# Access Compliance Report

## Public Rights-of-Way

### (Curb Ramps)

Intersection ID: 10038783	Main Street: STEELE_CREEK_RD	Cross Street: N/A	Location: SE
ADA ID: B72CED59BC92	Ramp Type: Directional1	Initial Pass/Fail: Pass	Overall Compliance: No
		Severity Score: 2.5

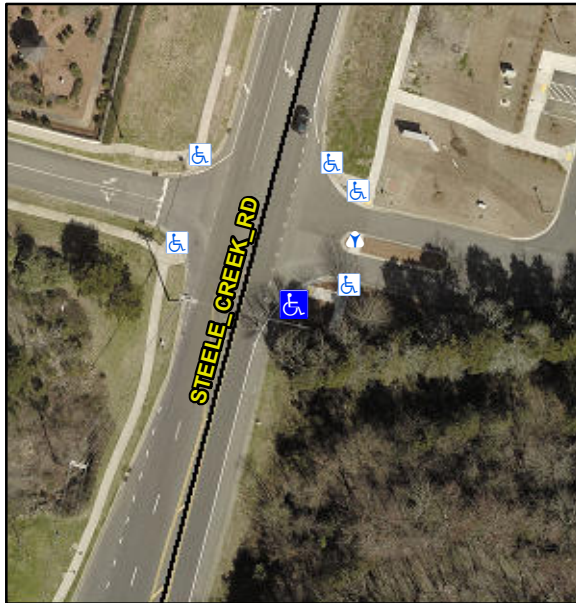
**Remove & Replace Detectable Warning System. Gutter Ponding Observed.**

**LNDG NOT SHARED**

**R305.1.4, R305.2, R302.7**
